**SUSQUEHANNA STEAM ELECTRIC STATION
PROPOSED LICENSE AMENDMENT NO. 285
FOR UNIT 1 OPERATING LICENSE NO. NPF-14
AND PROPOSED LICENSE AMENDMENT NO. 253
FOR UNIT 2 OPERATING LICENSE NO. NPF-22
EXTENDED POWER UPRATE APPLICATION
SUPPLEMENT TO REQUEST FOR ADDITIONAL
INFORMATION RESPONSES
PLA-6230**

**Docket Nos. 50-387
and 50-388**

The following provides the responses to NRC Questions 3, 4 and 8 contained in the Request for Additional Information Responses transmitted to NRC in References 2. The NRC Question and PPL Response for each is provided below.

Figure 4.10 Illustration of Final Quadratic Interpolation for Microscopic Thermal Cross Section of U-235

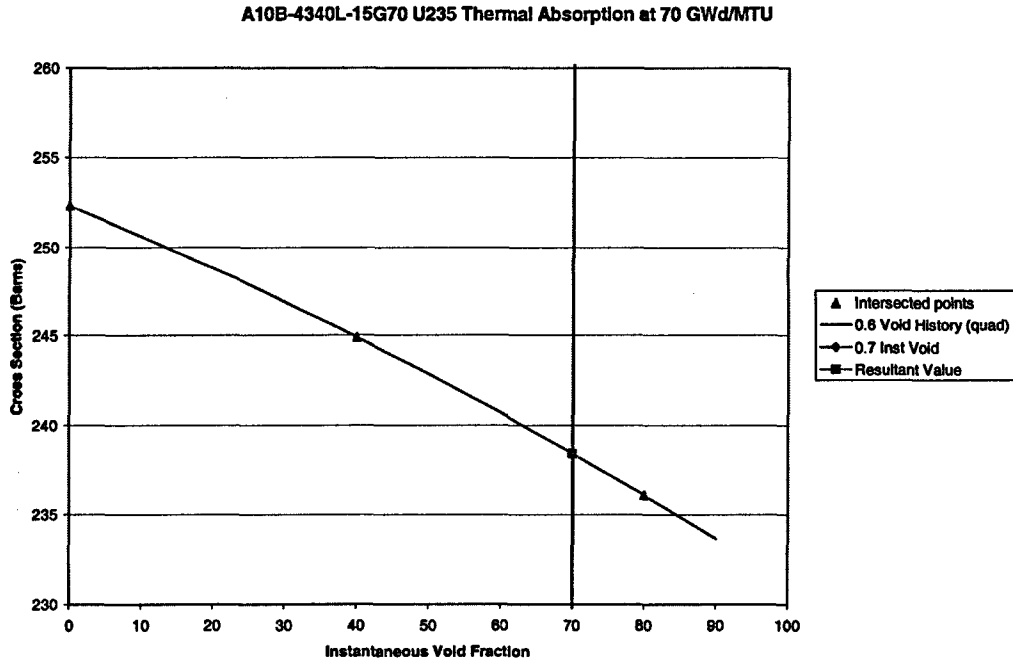
Quadratic interpolation is performed in each direction independently for the most accurate representation. Considering the case at 70 GWd/MTU with an instantaneous void fraction of 70% and a historical void fraction of 60% Figure 4.9 and Figure 4.10 illustrate the interpolation process. The table values

The intersection of the three quadratic lines with the historical void fraction of interest are then used to create another quadratic fit in order to obtain the resultant cross section as shown in Figure 4.10.

**Figure A.1 0.7 ft² PD SF-BATT TOP 108F
Upper Plenum Pressure (Lower)**

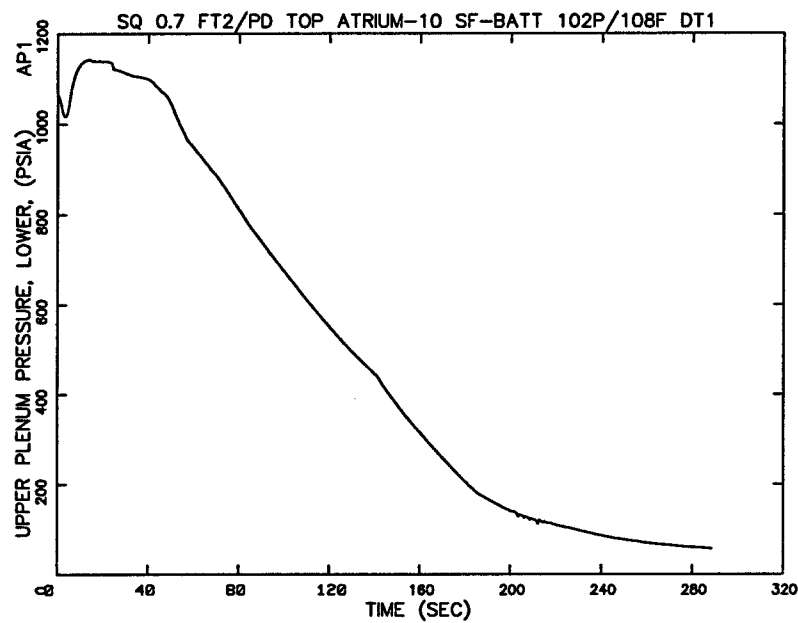
The NRC staff would like to confirm that the Susquehanna small break LOCA PCT result is not limiting compared to large break LOCA result. Specifically, the NRC staff requests PPL to provide the following information for the most limiting small break LOCA case (SF-BATT, 0.7 ft² split, top peak, pump discharge break).

- 1.1. Plant initial condition, axial power shape, radial peaking and local peaking factors.
- 1.2. Sequence of events.
- 1.3. Break size, ECCS flows and locations including HPCI, LPCI, LPCS and ADS.
- 1.4. Major parameter plots similar to large break LOCA results (Figure 6.1 to 6.27 in EMF-3242P)

PPL Response 1.4:

**Figure A.28 0.8 DEG PS SF-LPCI TOP 108F
Upper Plenum Pressure (Lower)**

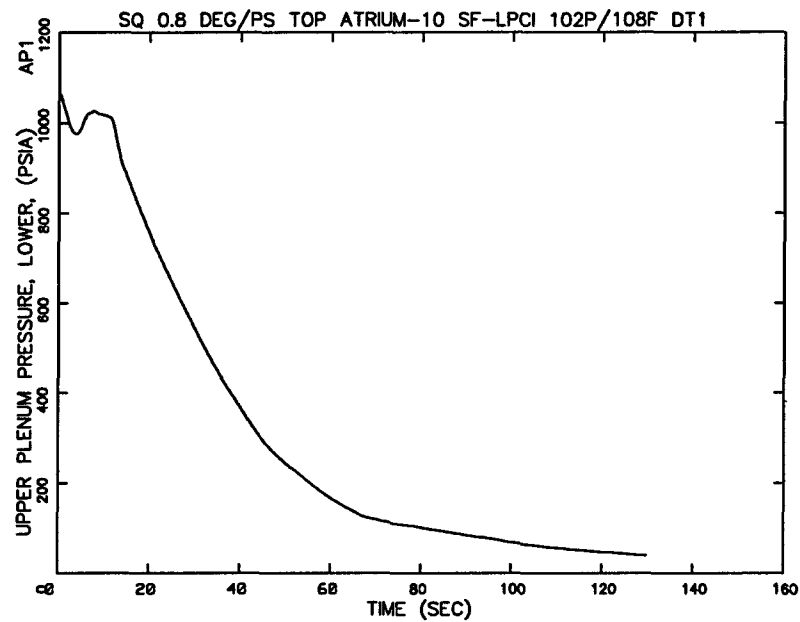
Per Table 6.9 of EMF-3242(P), the limiting LOCA for two-loop operation and a core flow of 108 Mlbm/hr is the 0.8 DEG pump suction (PS) break with SF-LPCI and top peak. Provide the corresponding major parameter plots similar to Figure 6.1 to 6.27 in EMF-3242(P).

PPL Response:
